SUNDRY NOTICES AND REPORTS ON WELLS (DO NOT USE THIS FORM FOR PROPOSALS TO DRILL OR TO DEEPEN OR PLUG BACK TO A DIFFERENT RESERVOIR. USE "APPLICATION FOR PERMIT" (FORM C-101) FOR SUCH PROPOSALS.)		WELL API NO. 30-005-60938

OPERATIONS SUMMARY

Well Name **Bitter Lake PX State #001**
API # 30-005-60938
Location Unit M-Sec 16-10S, R25E

WELLBORE DIAGRAM P&A'd

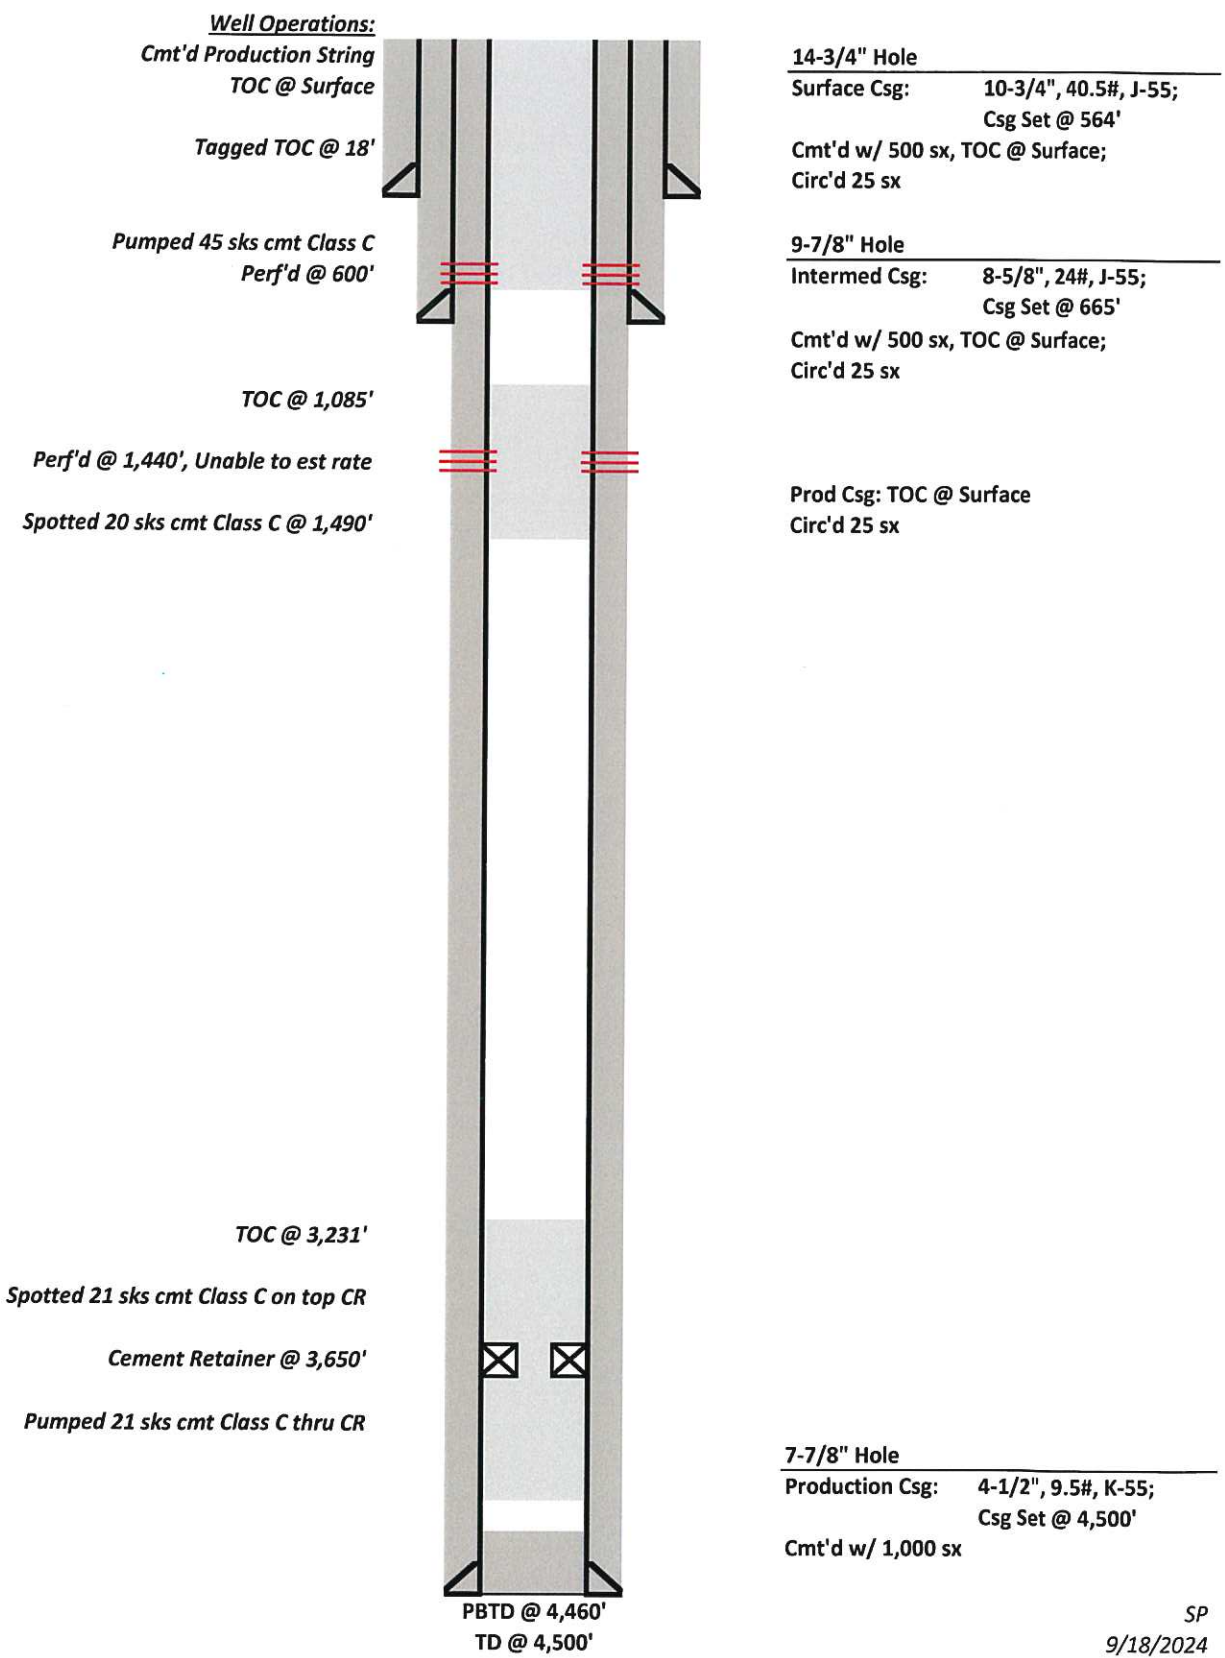
Request: Since we are unable to get below 3,659' due to 1/4" line and unable to retrieve significant lengths;
Can we alter plugging operations to set CIBP @ 3,650' (being 150' higher than approved procedure)?

As per conversation
Set CR @ 3650'
SQZ 21 SXS (1.5 TIMES VOLUME)
Spot 21 SXS ON CR THIS WILL COVER ABO FORMATION.
WOC AND TAG
